**ADDENDUM  
NO. 02**

**February 16, 2024**

**ZCS-ZCHS Stadium Locker Building & Concrete Repairs, ZMS Tennis Courts  
and Eagle Elementary Building Demolition & Playground Renovation  
1000 Mulberry St.  
Zionsville, IN, 46077**

Zionsville Middle School – Tennis Complex Renovation

4 CENTER STRAP ANCHOR SECTION  
Scale: NOT TO SCALE

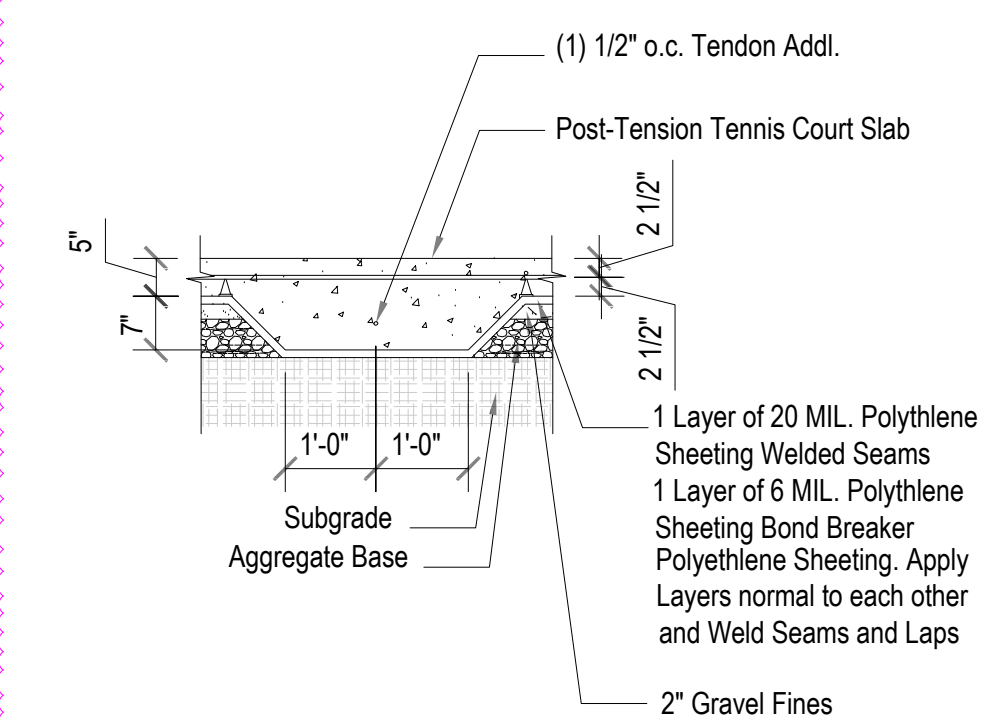
<b>ADDENDUM NO. 02</b>					
			<ol style="list-style-type: none"> <li>DET 4/G4.01 thickened slab for center strap anchor section does not have a dimension on the width of the thickened slab</li> <li>For the underslab vapor barrier is it 2 layers of 10 mil DET 5/G4.01 or 1 layer of 20 mil &amp; 1 layer of 6 mil DET 4/G4.01</li> <li>DET 1/G4.00 mono curb &amp; walk doesn't have a depth dimension for the mono curb</li> <li>Can the sidewalk go to 4" instead of 6"</li> </ol>		<ol style="list-style-type: none"> <li>Refer to Addendum 2 drawing.</li> <li>Refer to Addendum 2 drawing.</li> <li>Refer to Addendum 2 drawing.</li> <li>Sidewalks must be 6" thick.</li> <li>Refer to Addendum 2 drawing.</li> <li>Refer to Addendum 1 drawing.</li> </ol>
